PAS3- Clone PC5 Line Preamp assembly and installation instructions v2a 01-2022

This is our clone PC5 pcb upgrade kit, a direct drop in replacement for the old original Dynaco PC5 pcb assembly.

PCB layout

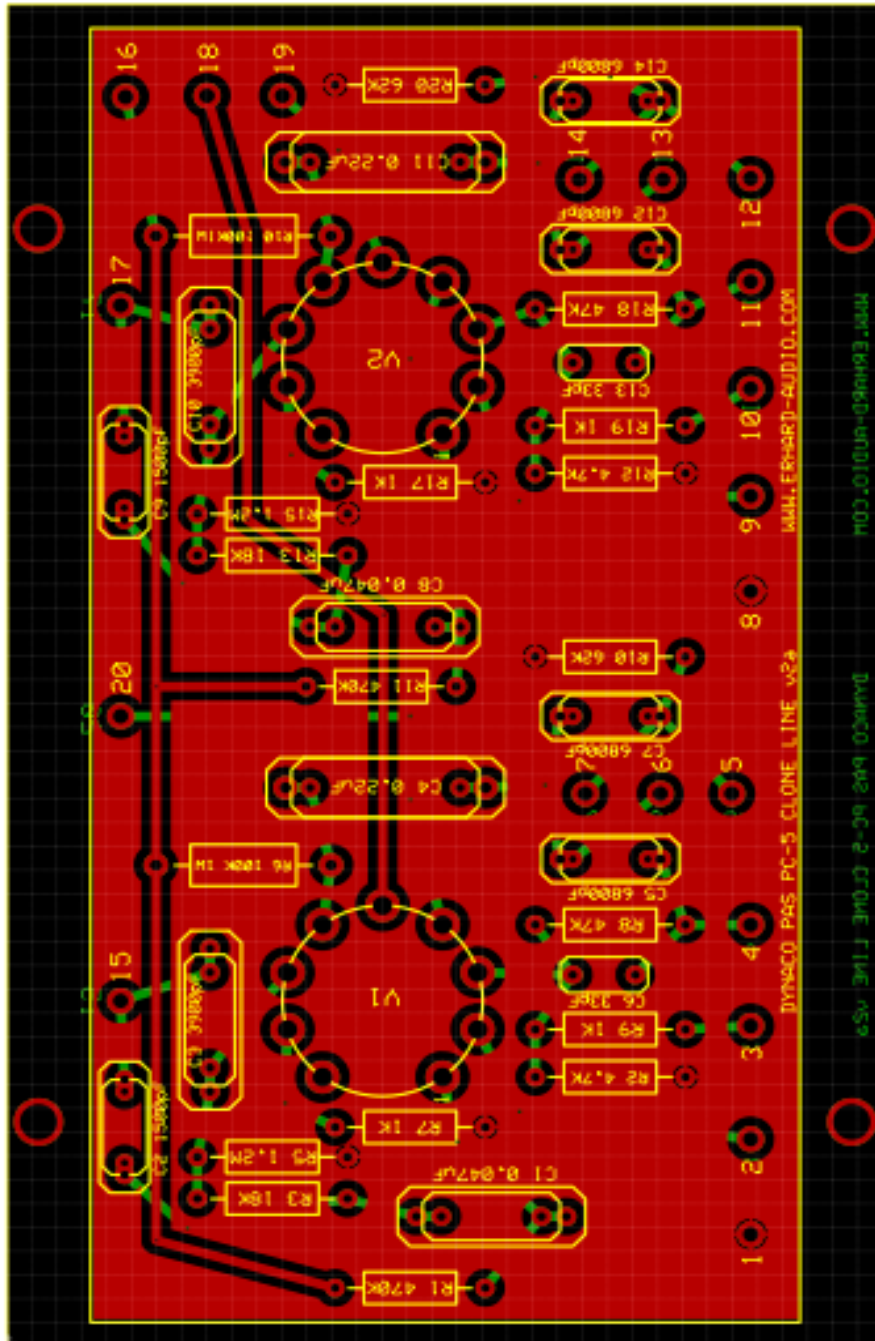
Addendum on parts values:

The following capacitors are marked incorrectly on the PCB, but are correct in the parts list and as supplied.

C3 & 10 should be 4000pF, not 3900pF. C5, 7, 12 & 14 should be 7500pF and not 6800pF. C1 & 8 should be 0.02uF and not 0.047uF.

All other part values on the pcb are correct.
